*Request for Competitive Solicitations  
Rebid Sands SLR Roadway and  
Drainage Pilot Project, Big Pine Key,  
Monroe County, Florida  
RFP-484-0-2023/la  
ADDENDUM NO. 3  
March 2, 2023*

SEA LEVEL RISE ROADWAY AND DRAINAGE PILOT PROJECT  
SANDS SUBDIVISION - BIG PINE KEY  
MONROE COUNTY - DEPARTMENT OF ENGINEERING

SHEET NO.  
RD-11B

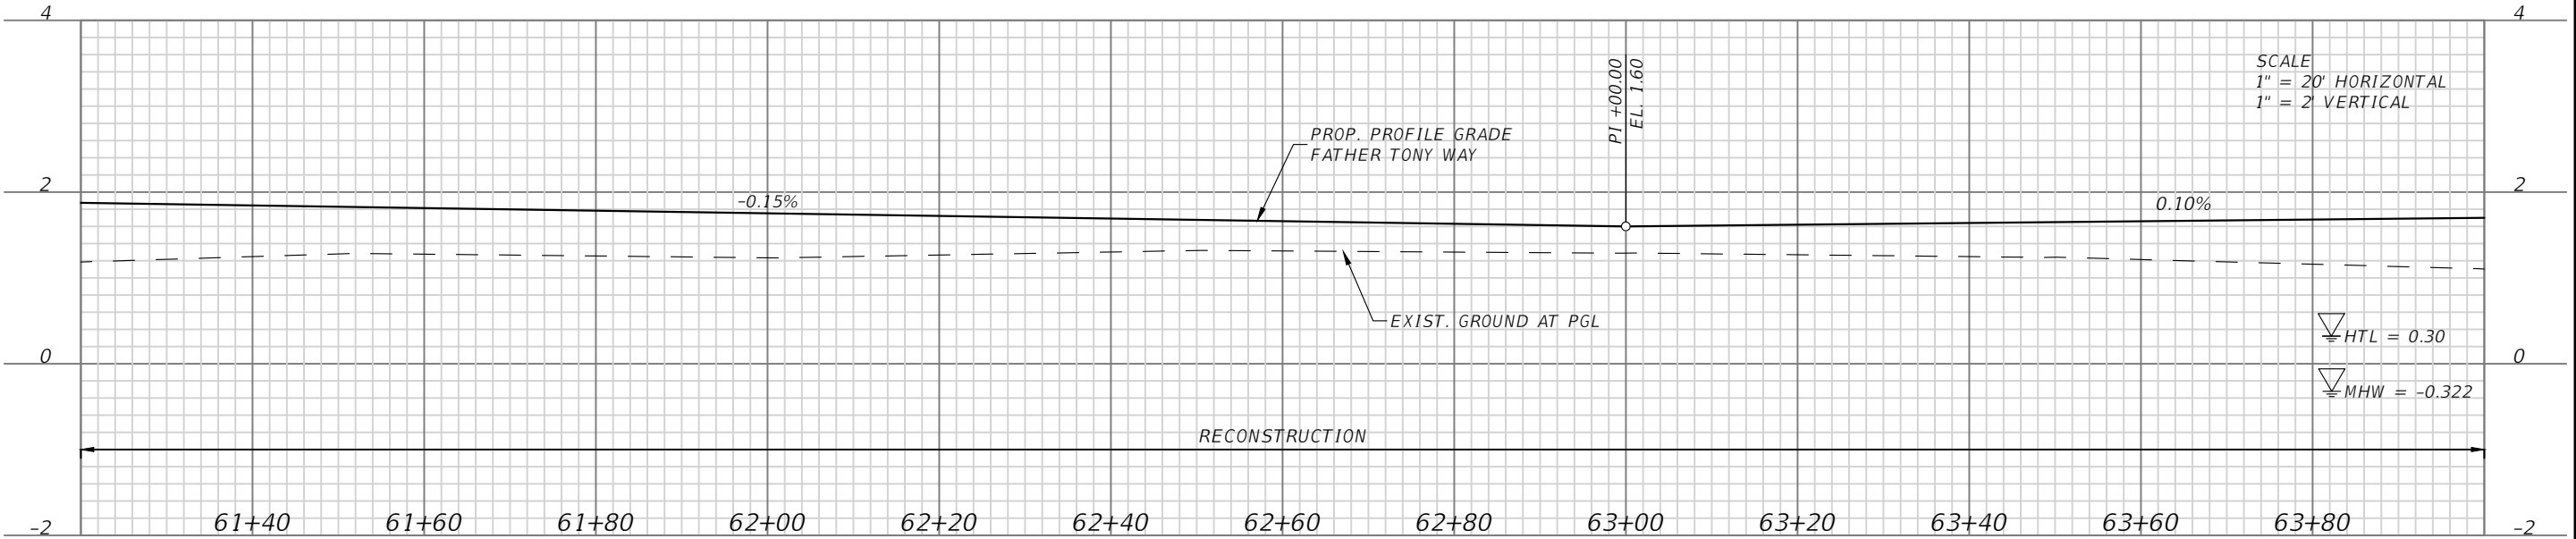
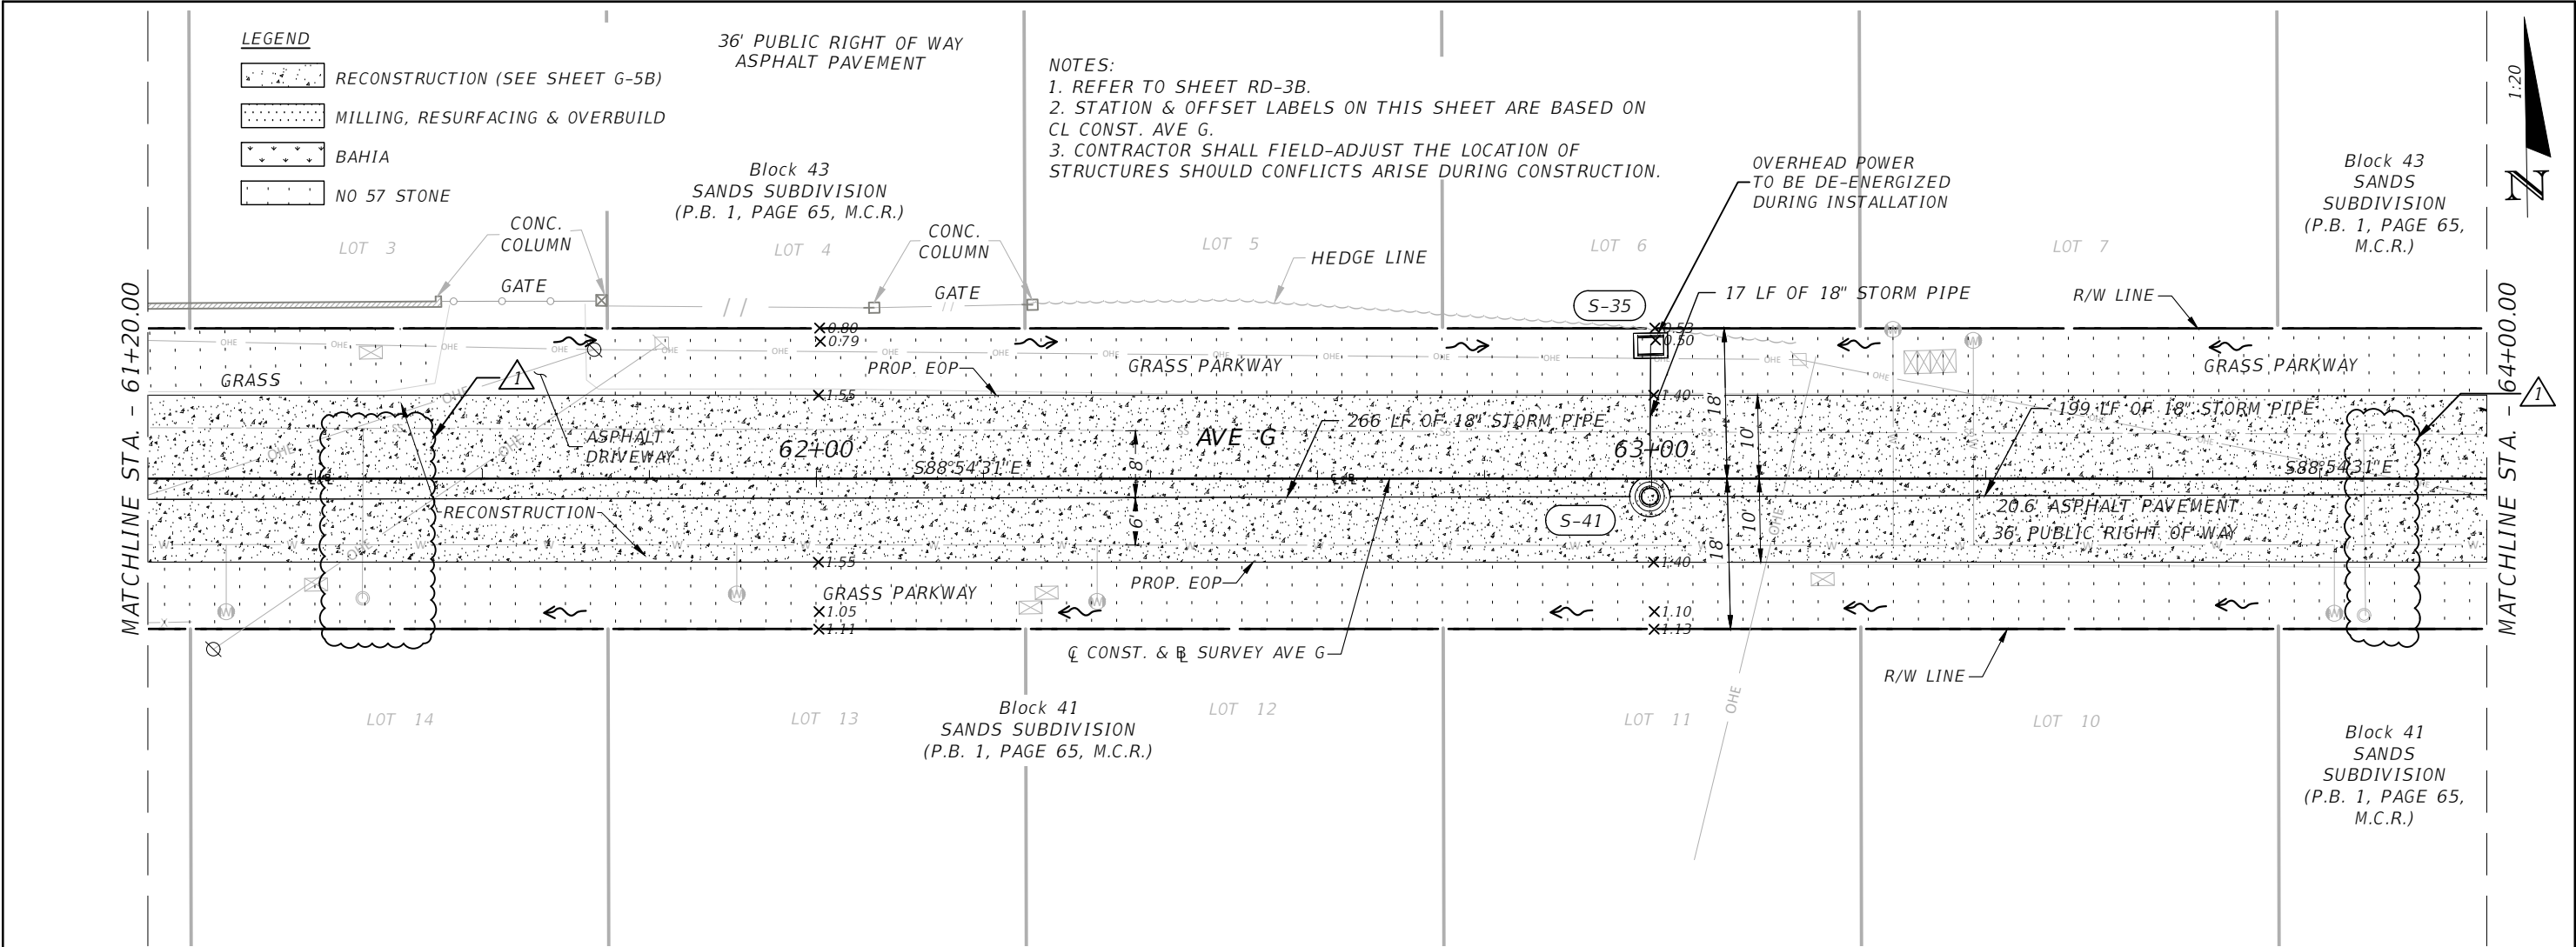
**EOR Clarification:** Sheets RD-11B and RD-13B have been revised to add the plan view of the sanitary utility pipes.

GENERAL LAYOUT

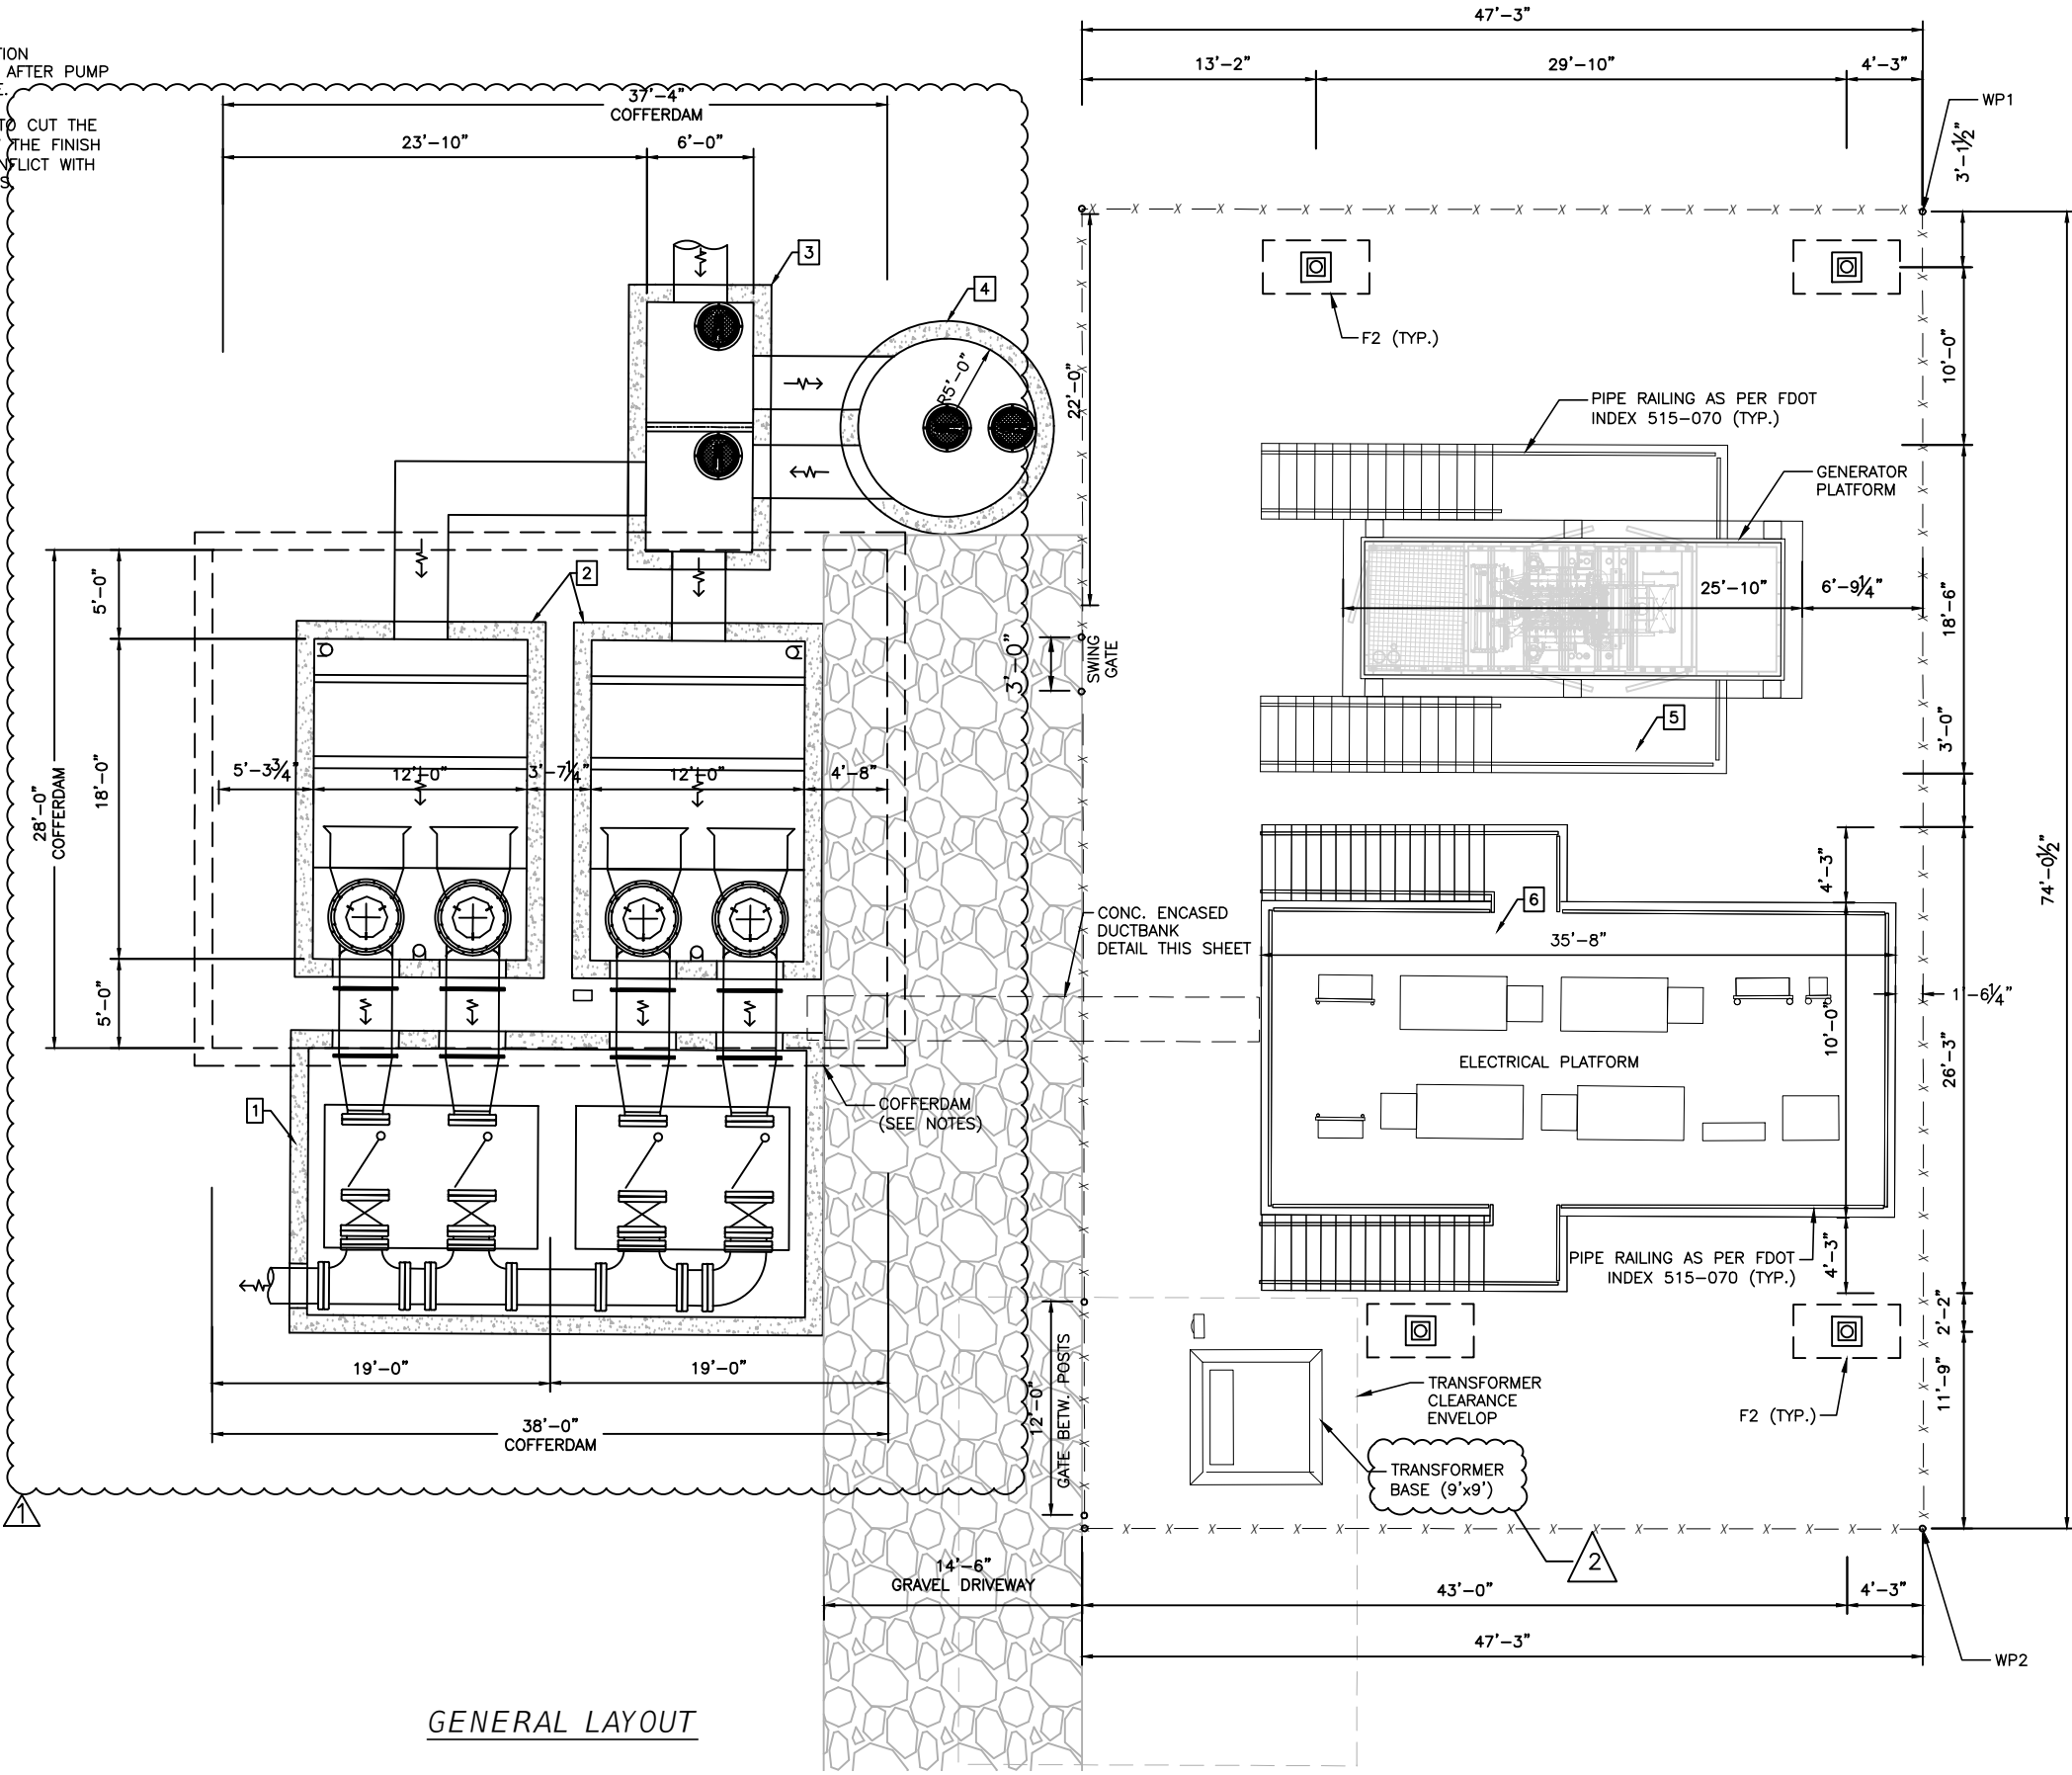
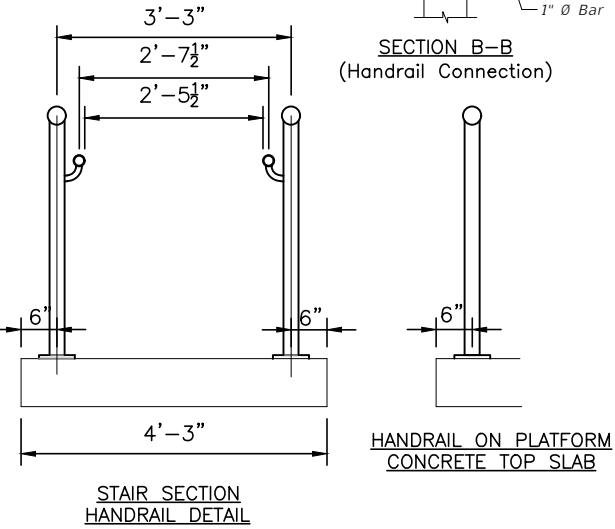
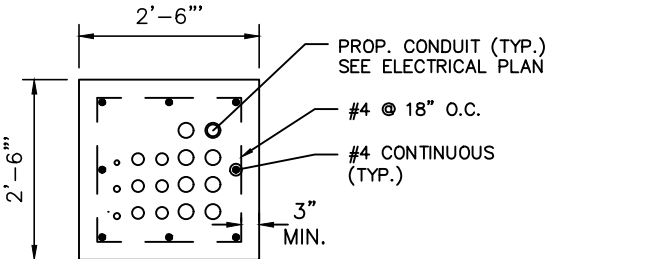
**Q2:** Please give the dimensions for the transformer base shown on sheet S1-B.

**R2:** Refer to revised sheet S1-B. The transformer base shall be 9'x9'.
